CALIFORNIA COASTAL COMMISSION

Prepared October 8, 2014 for October 10, 2014 Hearing

To: Commissioners and Interested Persons
From: Susan Craig, District Manager
Daniel Robinson, Coastal Planner
Subject: **STAFF REPORT ADDENDUM for F18a**
CDP Application 3-13-012 (Caltrans Piedras Blancas Realignment)

Exhibit 1: Layout Sheet (L-6)

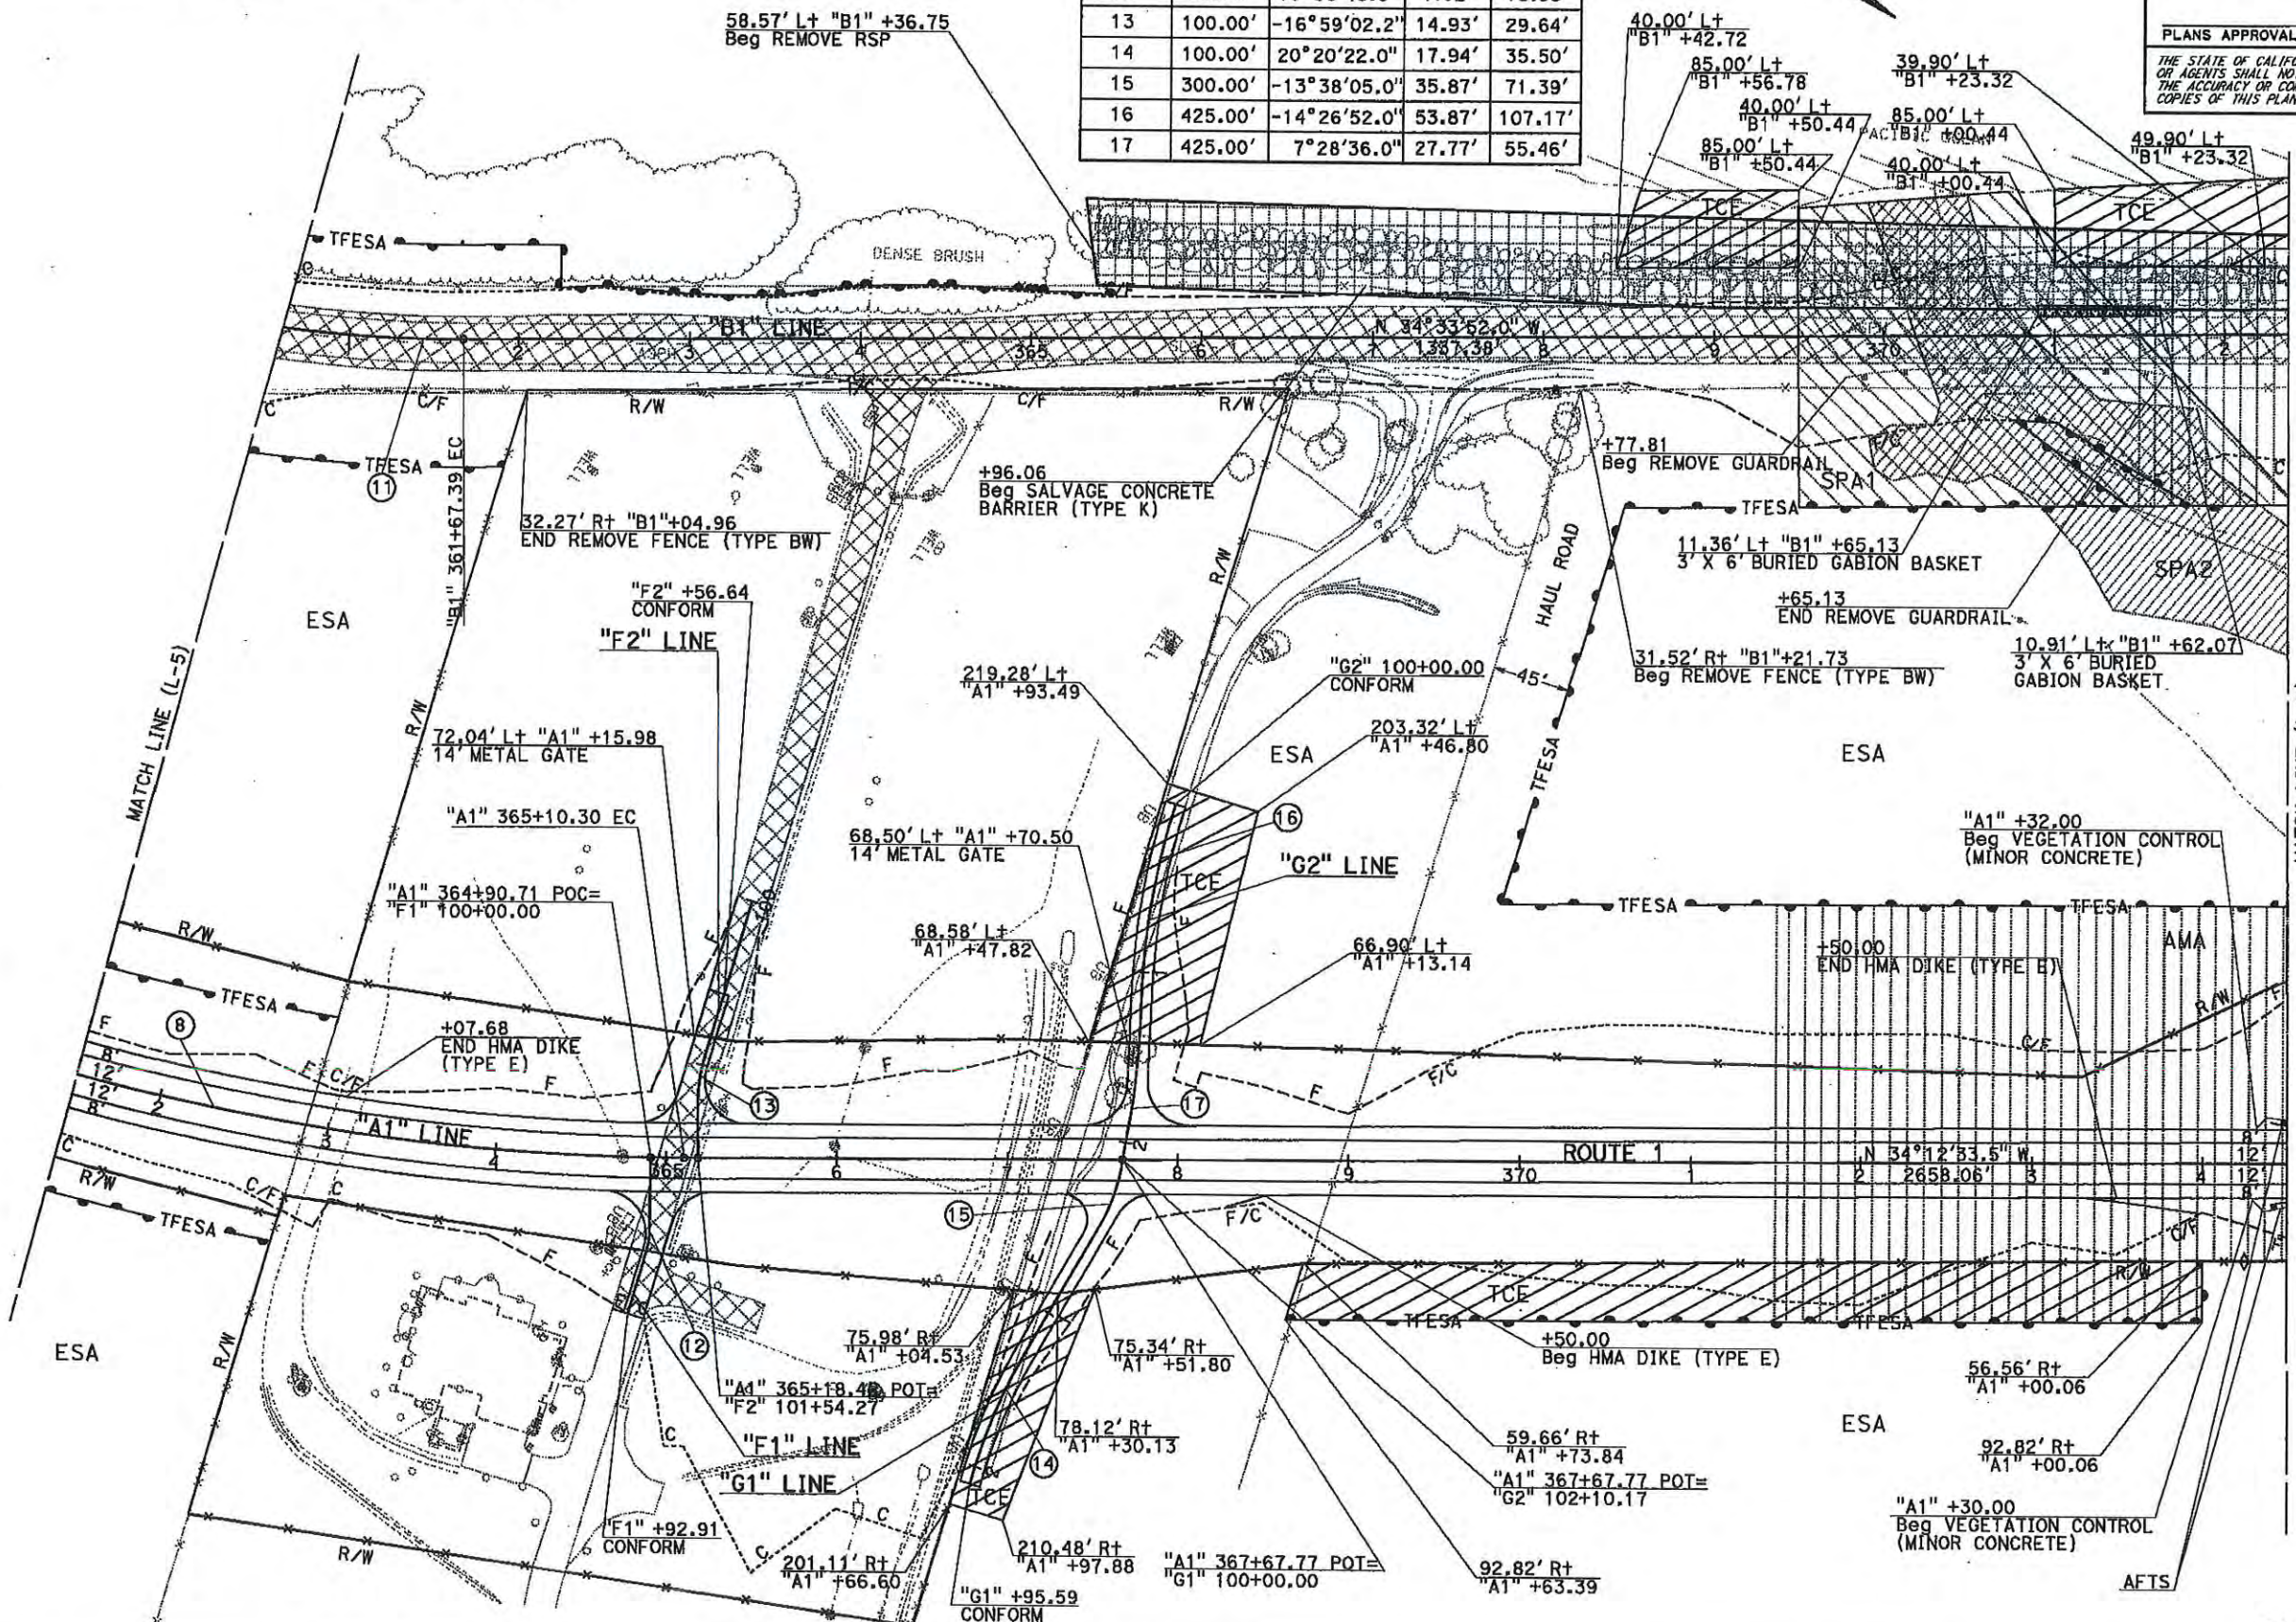
Please accept this letter in response to the Coastal Commission Staff Report Special Condition 2.e/Addendum 6.e (Driveway Access). Special Condition 2e. /Addendum 6.e requires that Caltrans eliminate the separate well access entrances servicing the wells for Sani parcel 3 (APN 011-231-015) and the Welsh parcel (APN 011-231-017) and replace them with a single informal, unpaved rangeland farm road.

As you are aware, the State has settled the eminent domain action against Sani parcels 1 and 2 (APNs 011-231-013 and 011-231-014) but remains in litigation on the Welsh parcel. The settlement agreement on Sani Parcels 1 and 2 provides Dr. Sani with a 40-foot access and utility easement as well as a 100-foot radius easement around the two remaining wells. Caltrans intends to remove the existing paved well access and convert it to an unpaved rangeland farm road. This access will also be steepened and hence, shortened to reduce its visibility (Exhibit 1).

While Caltrans is not the owner of the property subject to condition 2.e and does not have the right to remove the existing driveway, in the event that the current litigation results in the acquisition of the western portion of the Welsh parcel, Caltrans agrees to initiate discussions with Coastal Commission Staff to remove the existing driveway. Under this scenario, the State could then provide Mr. Welsh with easement rights to the well access on the parcels acquired from Dr. Sani and develop an unpaved rangeland farm road running north to Mr. Welsh's well (Exhibit 2).

At this time, Caltrans is requesting the Commission staff accept the current proposal to shorten and convert the existing paved well access on the acquired Sani parcels into an unpaved, rangeland farm road and to forego requirements to remove the Welsh driveway until and if settlement of the pending litigation results in acquisition of the western remnant of the Welsh parcel.
